*Re: TED-2008-051 – Sunlight Subdivision*

## Transportation Engineering Design Standards (TEDS) Exception Recommendation Form

Project Number: **FPP-2008-051**

Primary Project: Sunlight Subdivision

**STREET LIGHT PLAN - TEDS REQUIREMENT**

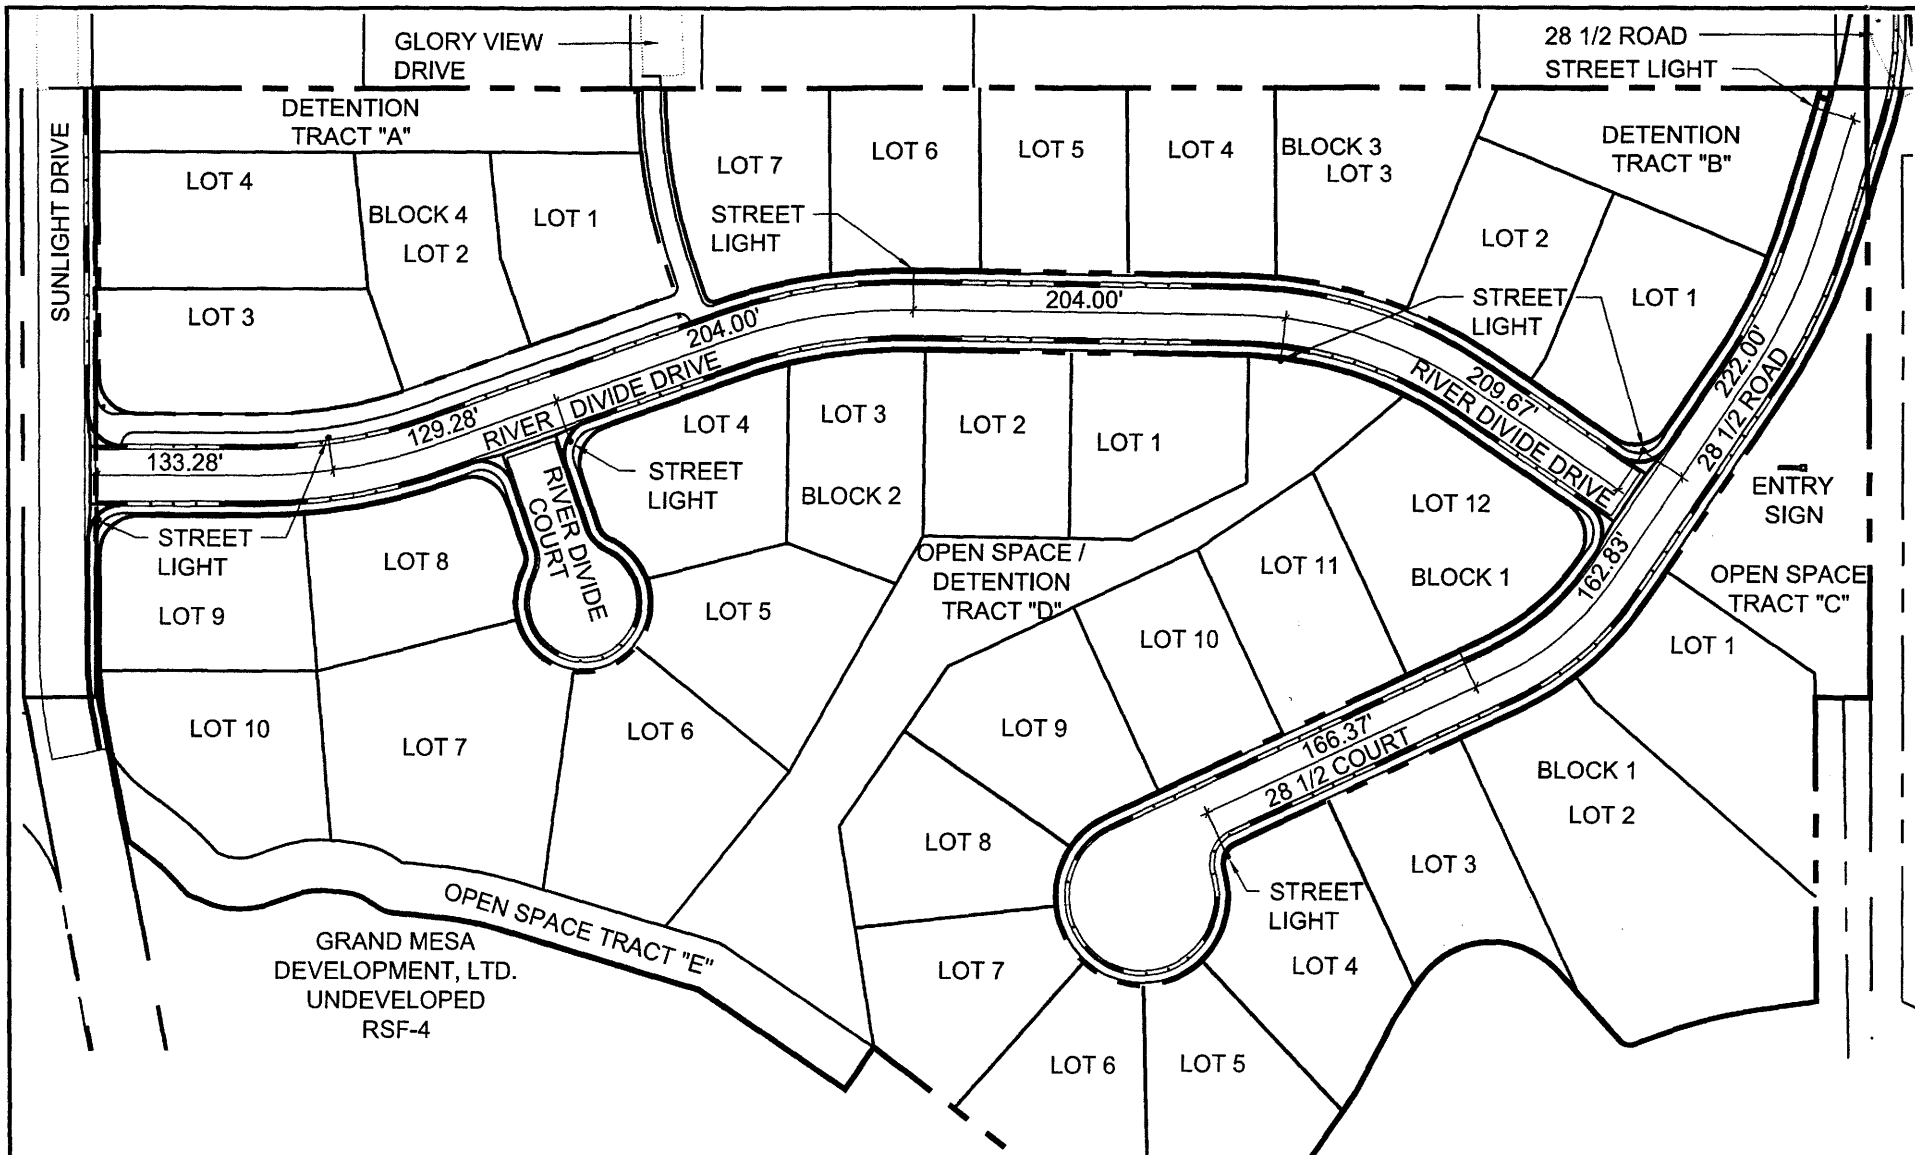
As shown on the attached drawing labeled Street Light Plan – TEDS Requirement, application of this standard requires the placement of nine streetlights. The applicant is requesting an exception to place streetlights only at the intersection of the proposed River Divide Drive with Sunlight Drive and the entrance to the subdivision where 28 ½ Road will be extended providing lighting at the two entry points to the development. The 28 ½ Road light will provide for lighting of the entry as well as the private access drive to the east.

As shown on the attached drawings, TEDS requirements can be met with nine streetlights. Alternatives exist to provide 3, 4, 5, 6, 7 or 8 lights as well but are not shown graphically. No other alternative exists that would meet this standard.

**STREET LIGHT PLAN - TEDS EXCEPTION REQUEST**

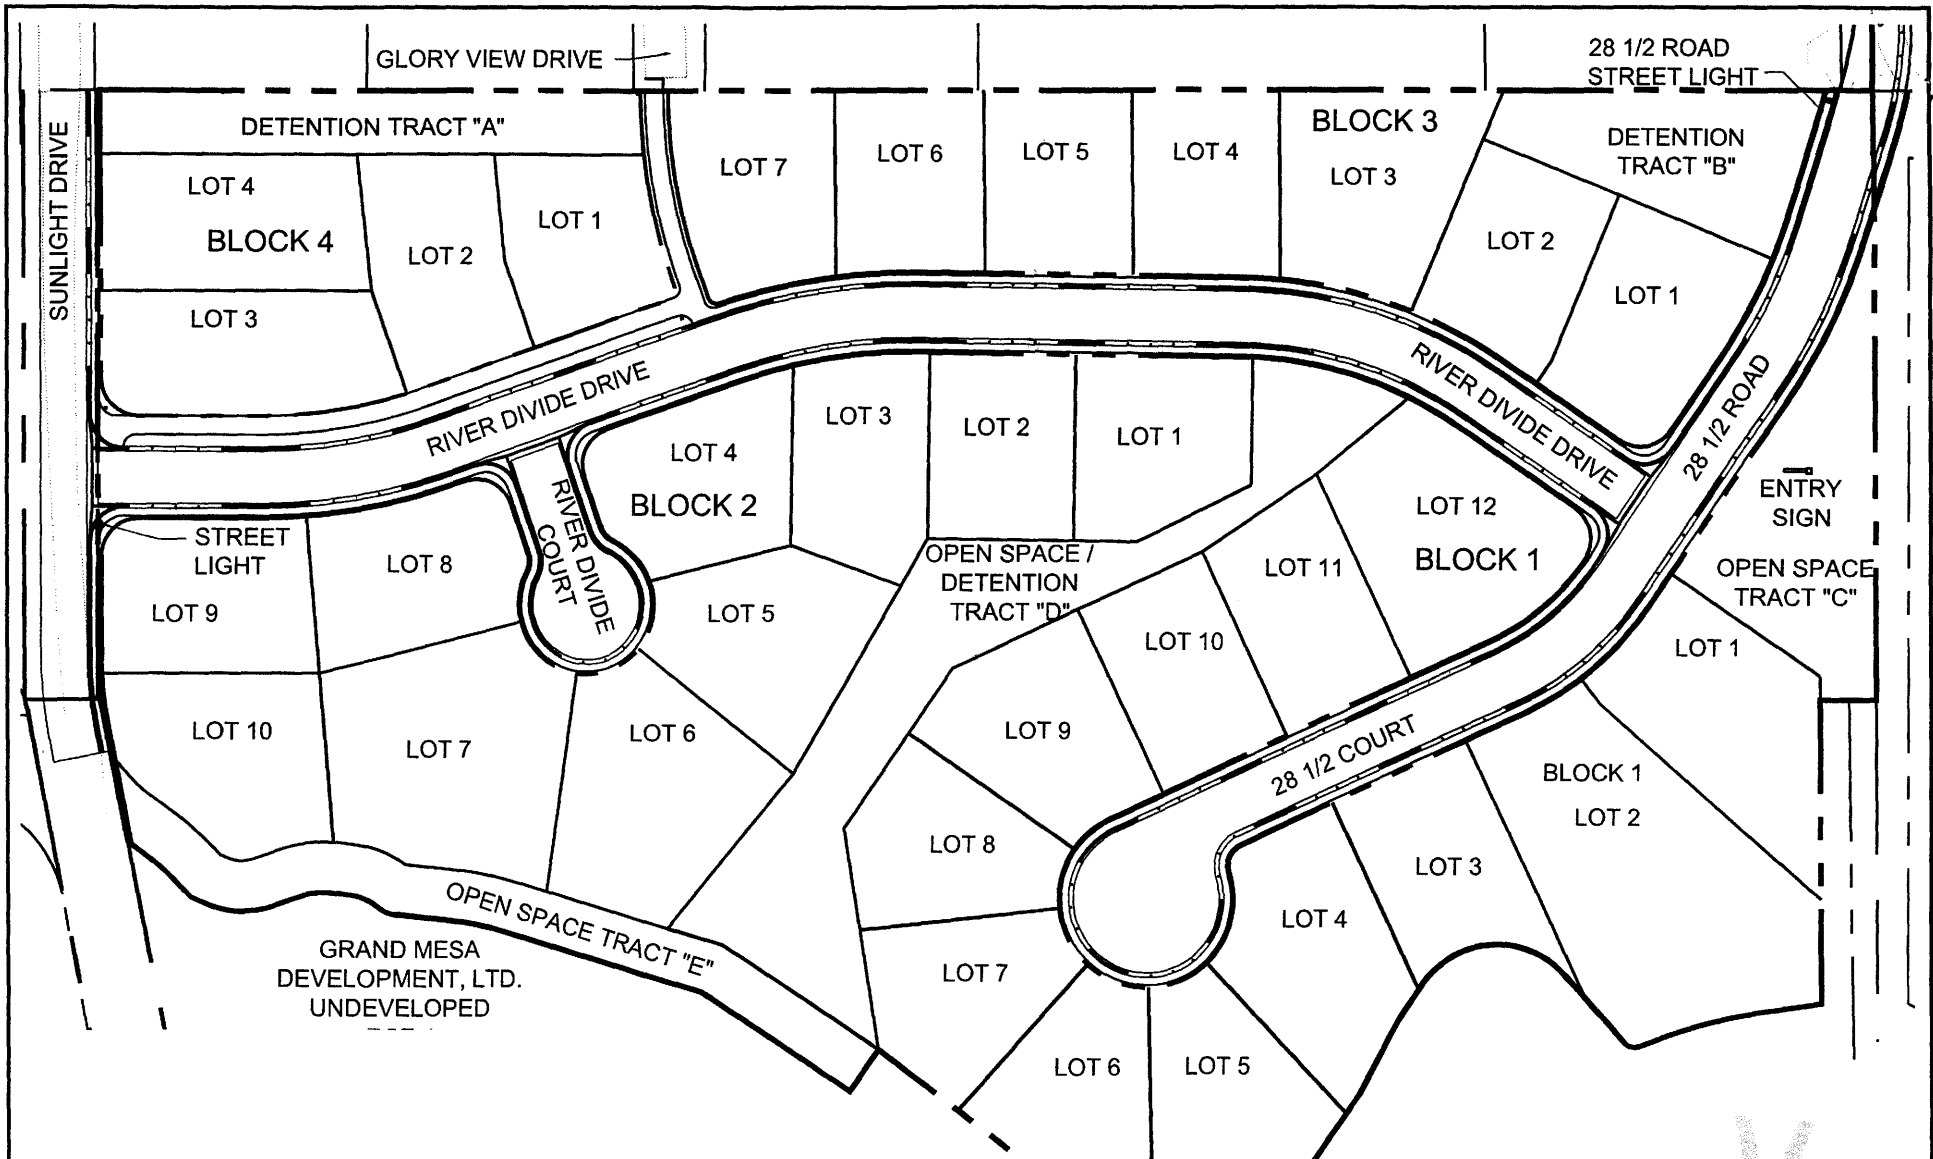
Comment: Request is to reduce street lighting from the 9 required by TEDS to only two at the two entrance intersections. Recent street lighting decisions have been to require street lights at all intersections; however, a meeting with many City departments a few months ago indicated street lights aren't essential for trash or emergency personnel.

This request is for an exception to the TEDS Manual Section 8.1 Street Lighting to reduce the required number of streetlights from nine to two. As proposed, streetlights would be located only at the project entrances at the intersections of Sunlight Drive and River Divide Drive and where 28 ½ Road enters the project.

- Approved as requested.  
 Approved with the following modification(s): *MOVE 28 1/2 ROAD LIGHT TO RIVER DIVIDE DRIVE INTERSECTION.*  
 Denied.  
 The following additional information is required before a decision can be made:
-
